MODIFICATION INSTRUCTIONS

Kodak X-Omat 3000 RA PROCESSOR

Kodak X-Omat 5000 RA PROCESSOR

To help prevent the possibility of film jams in the FIXER/WASH CROSSOVER, due to swelling of the ROLLER, and to install the latest version of software.

Figure 1 **3000 RA PROCESSOR**, Replacement of the “A” ROLLER — See Page 4 for the 5000 PROCESSOR

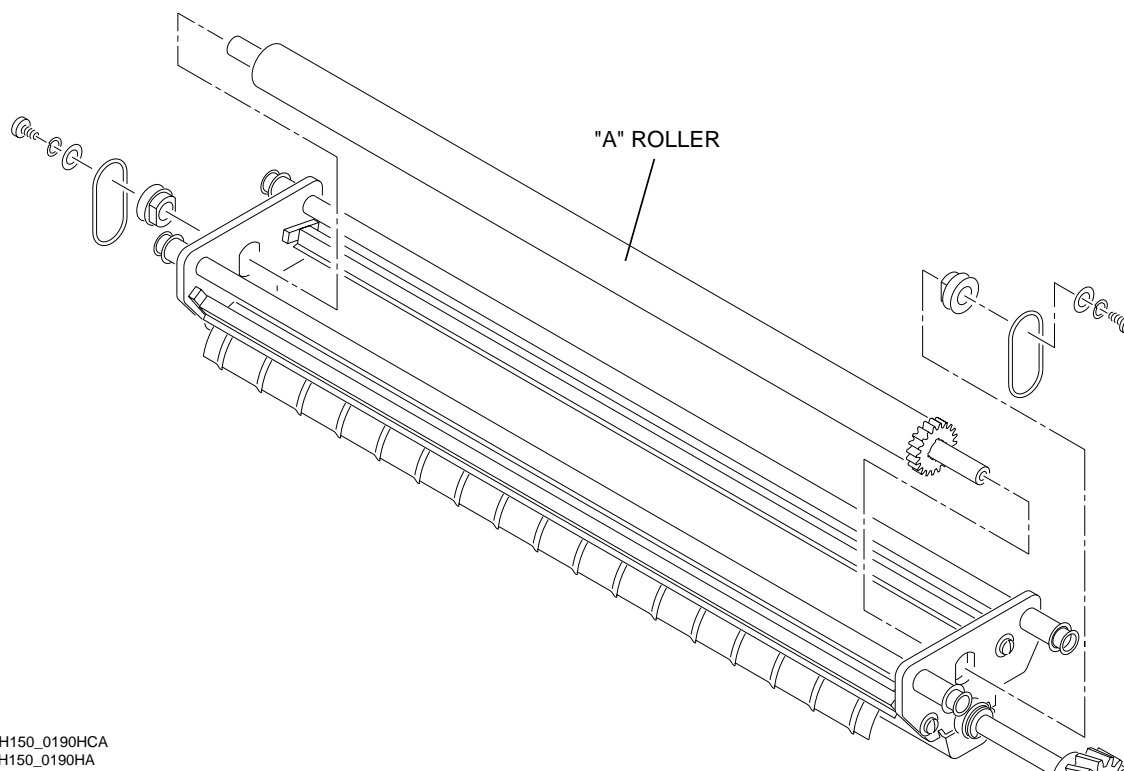
1. Remove the existing "A" ROLLER from the FIXER/WASH CROSSOVER.
 - See Figure 1 for the 3000 RA PROCESSOR on Page 3.
 - See Figure 2 for the 5000 RA PROCESSOR on Page 4.
2. Install the new "A" ROLLER from the Mod Kit.

ROLLER 9B8662 does not substitute for 467017 in all positions in the 3000 and 5000 PROCESSORS, only in the “A” position of the FIXER/WASH CROSSOVER.

3. Change the Part No. for the new “A” ROLLER in the Figures in the Parts List, and add the new Part No. to the Numerical and Alphabetical Indexes:
